Lower Thames Crossing 1.6 The Errata Report (Clean version)

DATE: August 2023 DEADLINE: 3

Planning Inspectorate Scheme Ref: TR010032 Application Document Ref: TR010032/APP/1.6

1.6 The Errata Report (Clean version)

Appendix A HRA Figure 24

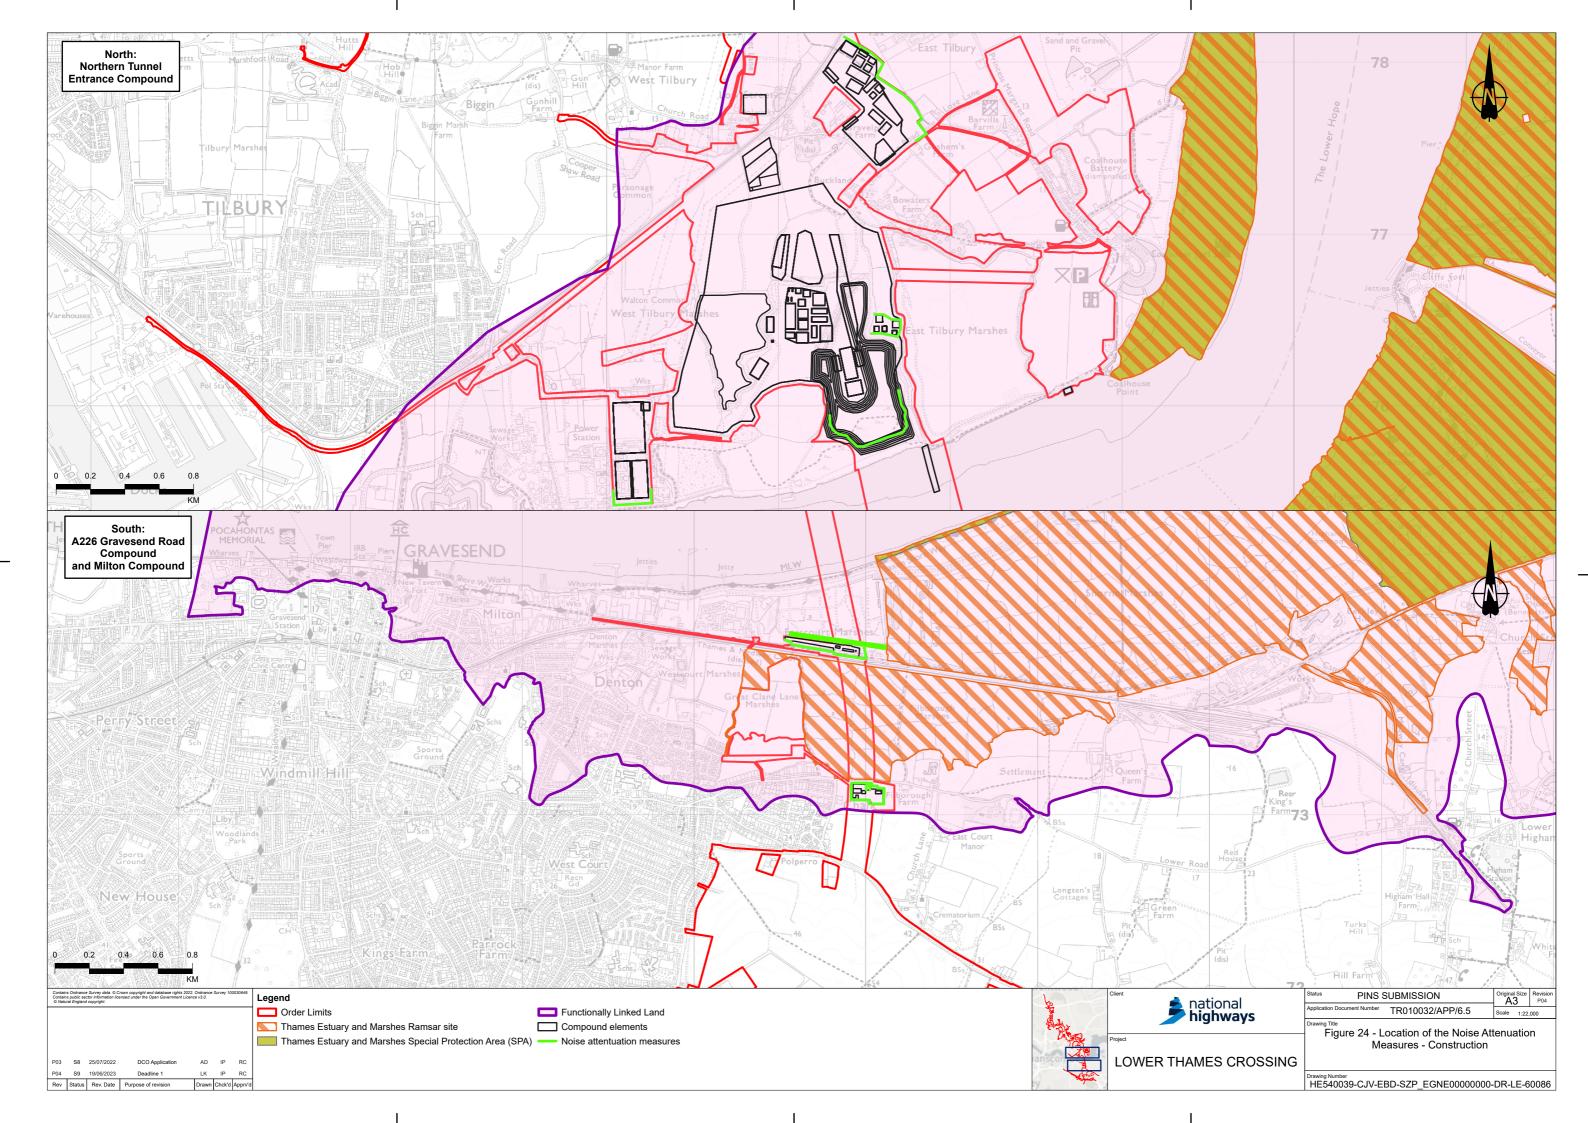
APP-487	D1	Habitats Regulations Assessment - Screening Report and Statement to Inform an Appropriate Assessment	Figure 24	Figure missing	Figure is cut off and does not include the full extent of proposed construction noise barriers	Figure updated and found in Appendix A of this document.
APP-495	D3	Planning Statement	Paragraph 5.3.24	Туро	Paragraph says "model provision." Should state "modal provision."	No change, Document not updated at this time.
